- Request - Major Site Plan Review for Multi-Family Housing
- Location - 1401 Monroe Street
- Applicant/Owner - Lucas Metropolitan Housing Authority
424 Jackson Street
Toledo, OH 43604
- Cherry Street Mission Ministries
1501 Monroe Street
Toledo, OH 43604
- Engineer - Lewandowski Engineers, A Verdantas Company
219 S. Erie Street
Toledo, OH 43604
- Architect - The Collaborative
One SeaGate, Park Level 118
Toledo, OH 43604

Staff recommends that the Toledo City Plan Commission approve SPR24-00098, Major Site Plan Review for multi-family housing at 1401 Monroe Street for the following **three (3) reasons**:

MAJOR SITE PLAN REVIEW
TOLEDO CITY PLAN COMMISSION
REF: SPR24-00098
DATE: January 16, 2025
TIME: 2:00 P.M.

SITE PLAN

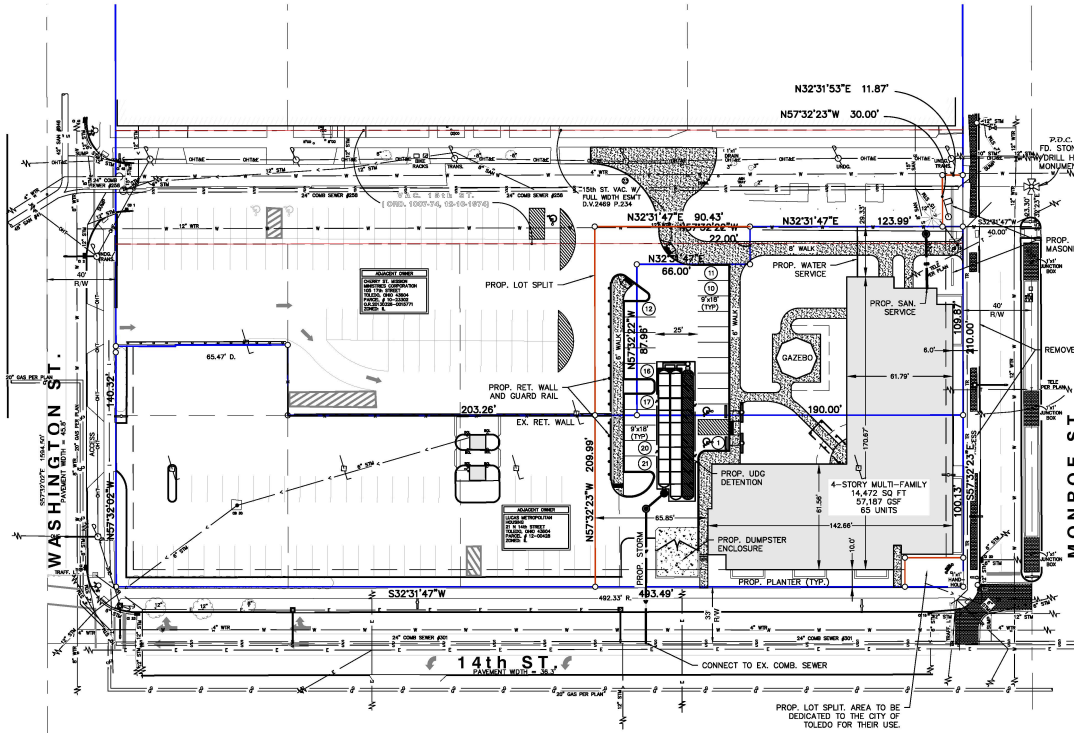
The site plan depicts seventy-three (73) parking spaces for the proposed building. Per the Off-Street Parking Schedule A in TMC§1107.0304, multi-dwelling structures are required to provide one and one-half (1.5) parking spaces for each dwelling unit plus one (1) parking space per ten (10) units for visitor parking. Calculations using 1.5 parking spaces for each dwelling unit (98) and visitor parking (7) result in one hundred five (105) parking spaces required to meet the minimum number of off-street parking requirements. To meet this requirement an additional thirty-two (32) parking spaces would need to be provided. Since the development is intended to provide supportive housing to the chronically homeless population, it is plausible that not all tenants will have their own vehicle and may instead use public transportation. In addition, the services provided by Cherry Street Mission Ministries are an integral component of the proposed development and as such parking is proposed to be shared between the facilities. The Plan Director is authorized to approve parking reductions if the applicant demonstrates the proposed plan will not adversely affect surrounding neighborhoods, traffic congestion and circulation, and will have a positive effect on the economic viability of the project per TMC§1107.1400. This is documented through the submission of an Alternative Access and Parking Plan. An alternative parking plan will need to be submitted to the Plan Director for review and approval prior to any building permits being issued as a condition of approval. This plan must detail the type of alternative proposed and the rationale for such a proposal, including supporting research on or documentation of parking demand for the proposed use(s) as well as a shared parking agreement.

Based on the seventy-three (73) off-street parking spaces provided, three (3) of the required parking spaces shall be designated as accessible parking for physically disabled persons and adhere to the requirements of TMC§1107.1700. One (1) space shall be van accessible and two (2) car accessible spaces. The site plan depicts two (2) van accessible spaces in the parking area immediately adjacent to the building. One (1) additional parking space is required and shall be provided in this parking lot as a condition of approval.

In addition to the minimum number of off-street parking and accessible parking spaces, bicycle parking is also required in the Off-Street Parking Schedule A in TMC§1107.0300. A minimum of one (1) bicycle slot shall be provided for every ten (10) automobile parking spaces. The proposed seventy-three (73) parking spaces on-site require eight (8) bicycle parking slots to be provided. There are no bicycle parking slots depicted on the site plan. Therefore, the site plan shall be revised to include the required bicycle parking slots as a condition of approval.

5. The stormwater planning is adequate for the Site Plan Review (SPR) phase, but the proposed sewer connection in 14th street may require change to connection at vacated 15th. Connection point may need to be at an existing structure. Proposing a new structure on the brick sewer may require structural lining first.

39. Off-street parking shall be provided per TMC§1107.0304 Schedule A for the proposed multi-family building. A total of one hundred five (105) parking spaces are required. The site plan depicts seventy-three (73) parking spaces. **Not acceptable as depicted. An Alternative Access and Parking Plan, in accordance with TMC§1107.1400, shall be submitted to the Planning Director to allow for a reduction of the required minimum off-street parking spaces, including a shared parking agreement.**

40. Bicycle parking slots shall be provided per TMC§1107.0304 Schedule A for the proposed multi-family use. Eight (8) bicycle parking slots are required. The site plan does not depict any bicycle parking slots. **Not acceptable as depicted. Site plan shall be revised to include the required eight (8) bicycle parking slots.**

41. All spaces reserved for the use by persons with physical disabilities shall adhere to the standards outlined in TMC§1107.1700. A minimum of two (2) car accessible spaces and one (1) van accessible space is required for the site. The site plan depicts two (2) van accessible spaces. **Not acceptable as depicted. The site plan shall be revised to include one (1) additional accessible space in the parking area closest to the building.**

46. Per TMC§1109.0103(A), connecting walkways may cross parking aisles or driveways if distinguished from driving surfaces through the use of durable, low maintenance surface materials such as pavers, bricks, scored concrete or scored and painted asphalt to enhance pedestrian safety and comfort. **Not acceptable as depicted. A distinguishable surface shall be installed on the drive surface from the sidewalk along the south side of the new parking area to the sidewalk that connects to Monroe Street.**

50. The proposed dumpster area shall be relocated so that it is not located along 14th Street and depicted on a revised site plan to be submitted to the Plan Commission for review and approval by the Plan Director.

LANDSCAPE PLAN

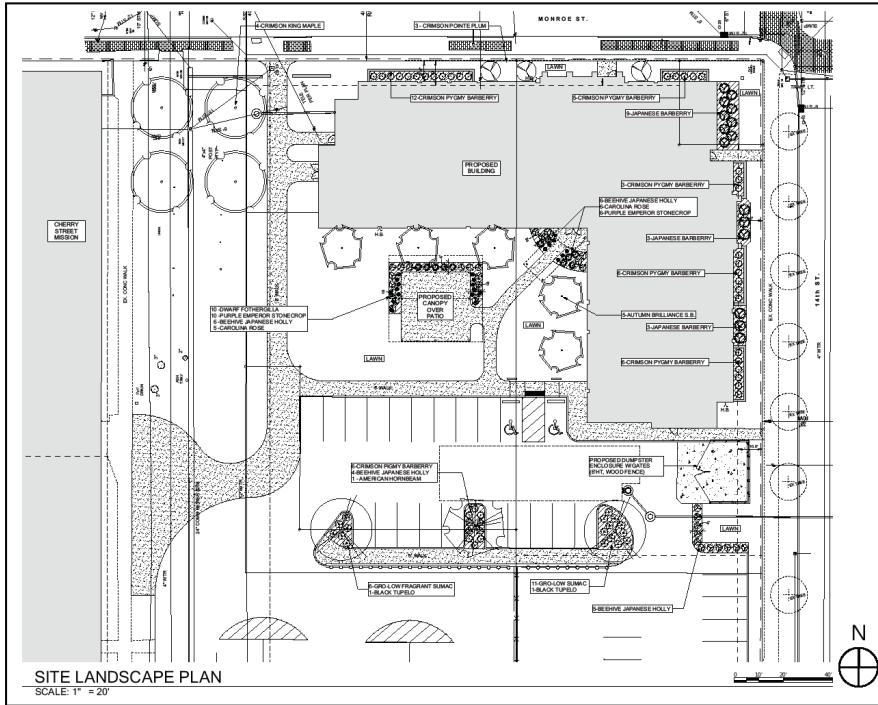
Since the subject site is within the CM Mixed Commercial-Residential Zoning District as well as the Uptown District Urban Neighborhood Overlay, the development is required to adhere to the Urban Commercial Landscape Standards. These standards as outlined in TMC§1108.0300 require any part of a lot area not used for buildings, other structures, or for roads, walks, parking, service areas or access ways be landscaped with a combination of groundcover, trees and shrubs. Grasses may be used in conjunction with other plant material. Landscape improvements must be provided in the sidewalk or other paved area in front of a building with tree grates, or other walkable surface material treatment for open tree pits, in the form of one (1) shrub or understory tree for every thirty-feet (30') of lot frontage. The landscaping plan depicts interior site landscaping that includes foundation plantings along Monroe Street and 14th Street, landscaping at the main rear entrance and around the outdoor patio/gathering area, trees along the rear of the building, and parking lot island landscaping. In addition, one (1) tree is provided for every thirty-feet (30') along the Monroe Street frontage.

Existing trees and shrubs are located along the 14th Street and Washington Street frontages. TMC§1108.0305 requires perimeter landscaping to be installed along any parking lot areas adjacent to a street, place, or driveway. While there are existing shrubs, they do not extend the full length of 14th and Washington Streets. Grant funding for the development is being utilized for the building site portion of the development with no proposed improvements to the existing parking area. This area may be improved in a future phase. At such time, the existing landscape shall be brought into compliance with the applicable landscape requirements as a condition of approval. Additionally, should mechanical equipment for the development be installed on the ground on the exterior of the building, its location and required screening shall be shown on a revised site and landscaping plan and approved by the Plan Director as a condition of approval.

- a. Urban Commercial Landscape Standards of TMC§1108.0300, any part of a lot area not used for buildings, other structures, or for roads, walks, parking, service areas or access ways must be landscaped with a combination of groundcover, trees and shrubs. **Acceptable as depicted.**

- b. Landscape improvements must also be provided in the sidewalk or other paved area in front of a building with tree grates, or other walkable surface material treatment for open tree pits, in the form of one (1) shrub or understory tree for every thirty-feet (30') of lot frontage. **Acceptable as depicted.**

- e. Pursuant to TMC§1108.0305, perimeter landscaping must be installed along any parking lot area adjacent to a street, place, or driveway. **Acceptable as depicted for this phase. When the existing parking area is improved in a future phase, the existing landscape shall be brought into compliance with the applicable landscape requirements.**

- h. The location, number, height, diameter and species of any materials to be planted and maintained, as well as the location and number of any existing trees to be retained, trees, shrubs, and landscape materials shall meet the standards included in TMC§1108.0400 Landscape Materials Standards. **Acceptable as depicted.**
